Proposal Request

PROJECT: *(name and address)*
AWSOM
Bentonville, Arkansas

PROPOSAL REQUEST 039

MSE Walls, Curbs, and Grading

6 MSE WALL GUARDRAIL - 3D VIEW

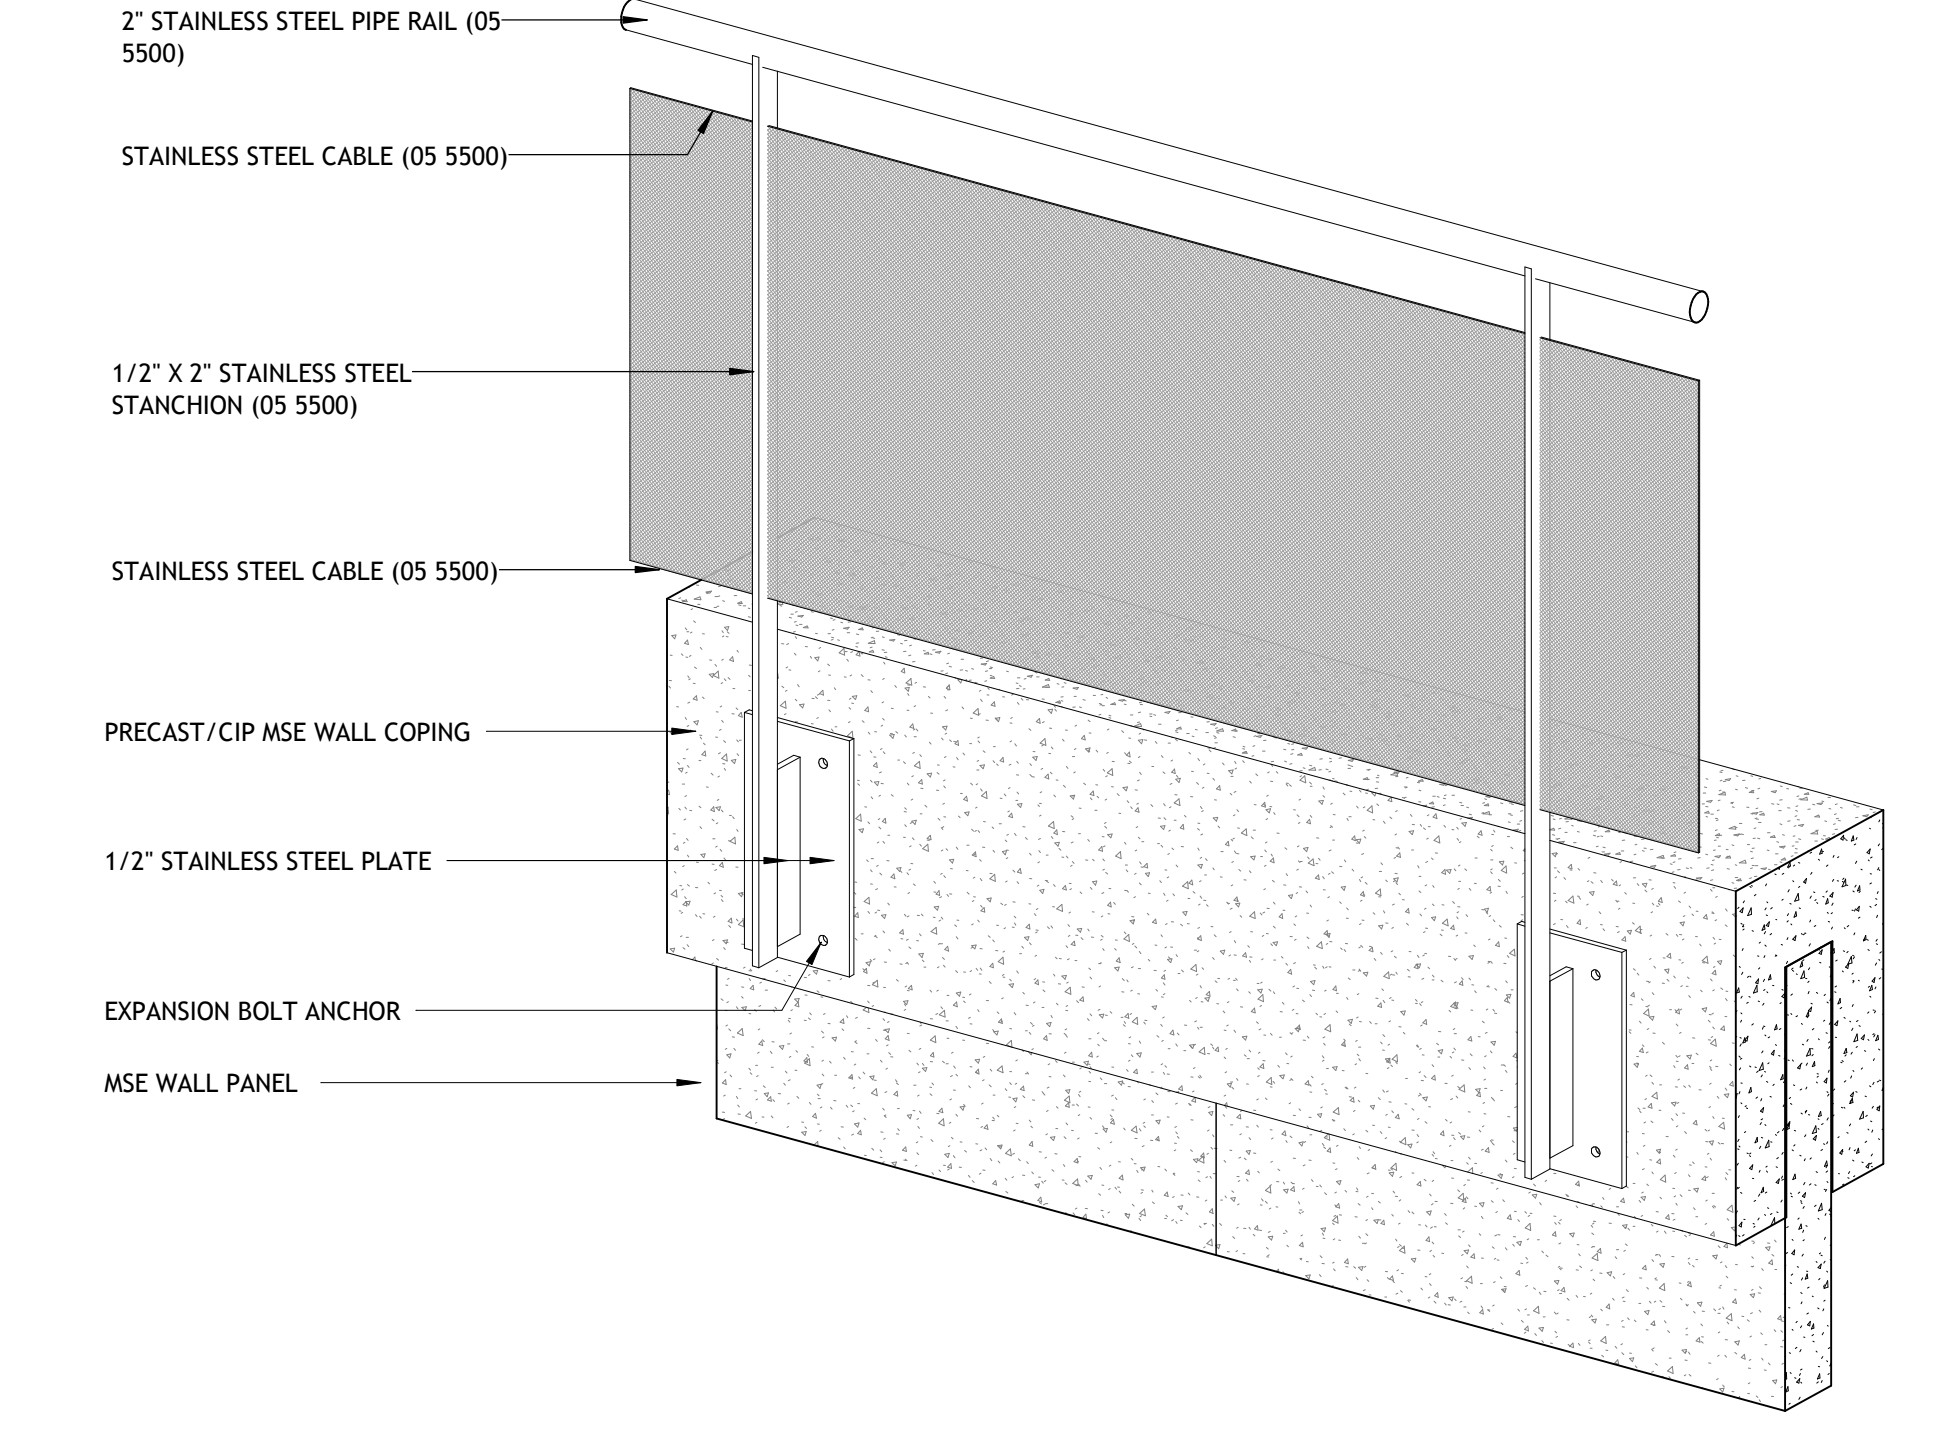
- a) Refer to Revised Sheet **A100AD**, with original issue date 02.24.2023 and revised date 04.04.2024.
 - Dimensions on MSE wall revised.
- b) Refer to Revised Sheet **A100BD**, with original issue date 02.24.2023 and revised date 04.04.2024.
 - Dimensions on MSE wall added.
 - Note on landscaping curb added.
- c) Refer to Revised Sheet **A101A**, with original issue date 02.24.2023 and revised date 04.04.2024.
 - Notes on MSE walls omitted.
- d) Refer to Revised Sheet **A101B**, with original issue date 02.24.2023 and revised date 04.04.2024.
 - Notes on MSE walls omitted.
- e) Refer to New Sheet **A607**, with original issue date 04.04.2024.
 - New MSE wall layout added.
 - New guardrail details added.
